ADDENDUM # 2

***Title: Replacing Floor at the University of Rhode Island, Providence
Campus***

ADDENDUM 2

- 1.01 DATE: **March 3rd, 2014**
- 1.02 PROJECT: **Dept. of Education (DOE) Flooring Replacement**
- 1.03 PROJECT NUMBER: **1301J, BID NO. 7548470**
- 1.04 OWNER: **University of Rhode Island**
- 1.05 ARCHITECT: **Brewster Thornton Group Architects, LLP**

SKA-1

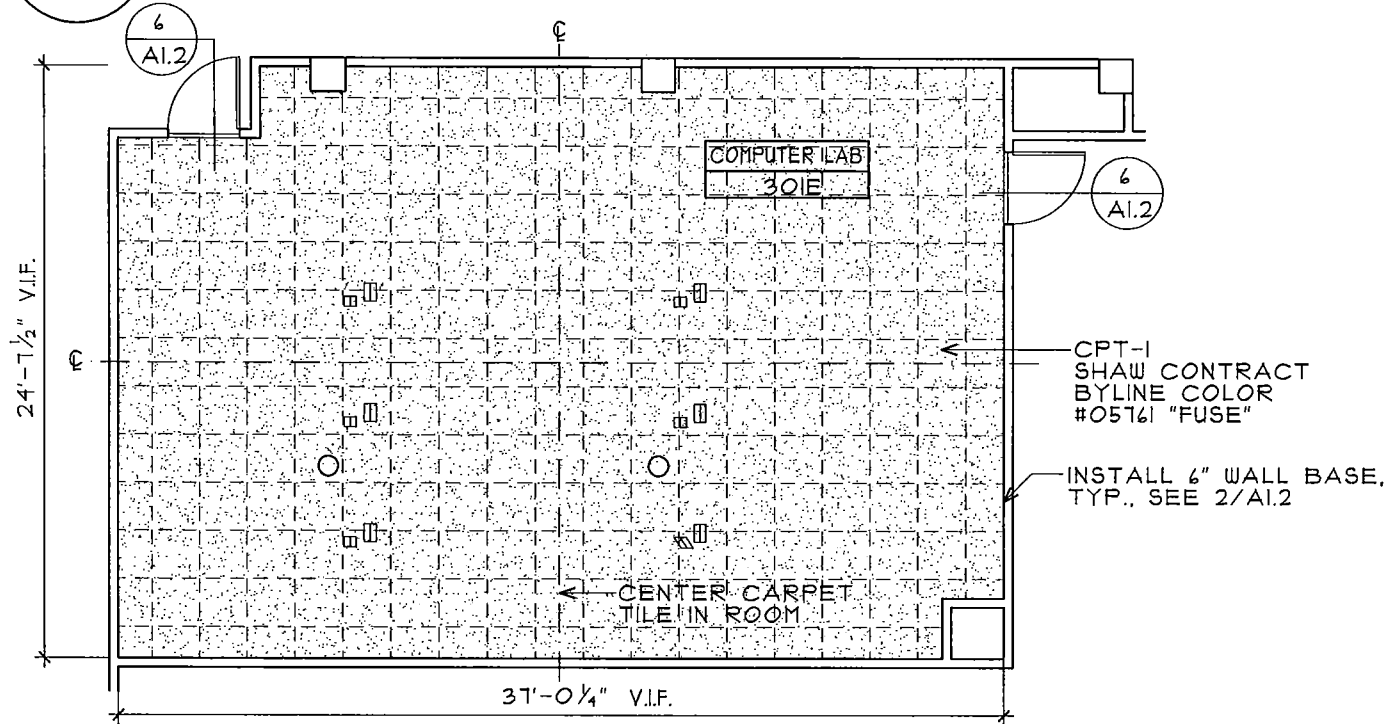
- 4.01 On sheet D1.1, change the phrase in the LEGEND box from "REMOVE AND DISPOSE OF CARPET" to "REMOVE AND DISPOSE OF VCT". Correct the spelling of "installation" in that same note.
- 4.02 Add Sketch SKA-1 dated 03/03/14. This sketch describes an additional room of carpet to be included in the base bid. Note the value of this added work in the breakout price line on the revised Bid Form issued with this Addendum.
